## TERMINAL RAILROAD ASSOCIATION OF ST. LOUIS

**RE: New Proposed Mississippi River Bridge**

1. Preliminary drawings developed by HNTB reflect 8 pier locations, (16 piers), on TRRA right-of-way at the Wiggins #2 yard location.
2. Horizontal clearances are listed to proposed piers as 25'-0" minimum which is acceptable to TRRA. It is noted that Pier #20 has horizontal clearances less than 25'-0". The supplied detail appears to meet AREMA requirements for pier protection walls. Approval will depend upon a detailed review of the crash wall design to be done upon final submittal.

## TRRA OVERHEAD SUBMITTAL CHECKLIST

# PREFERRED ACCESS ROAD LAYOUT

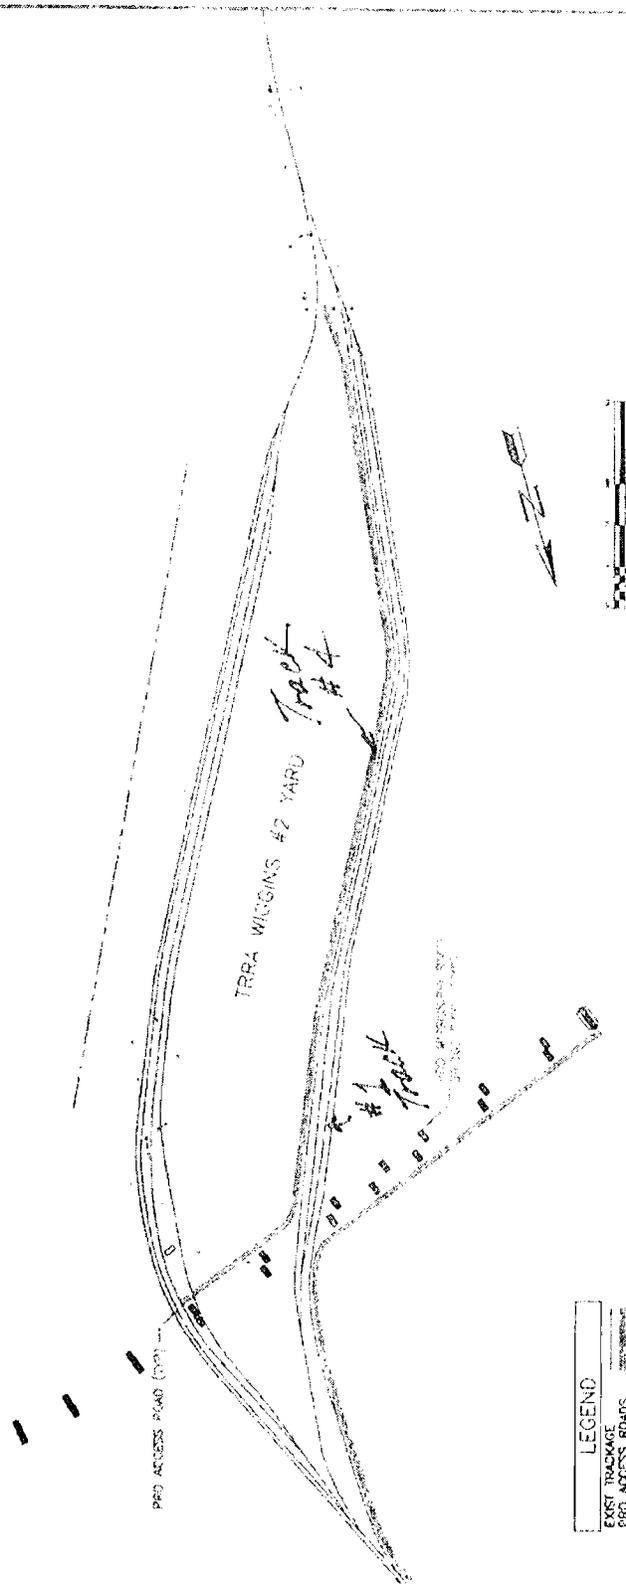
3. Vertical clearances are listed to bottom of structure as 23'-6" minimum which is acceptable to TRRA.
4. North access road to be parallel to Track #1 on the west side of the yard. South access road to parallel Track #4 on east side of Track #4. TRRA to review final access road alignments, profile and grading plans upon final submittal. Roads to be constructed of 12" compacted aggregate with a shoulder 30' from near track. Access road profile to match existing railroad subballast profile, approximately 2' below top of rail elevation, with cross slope draining away from existing tracks. See attachment for preferred access road location.
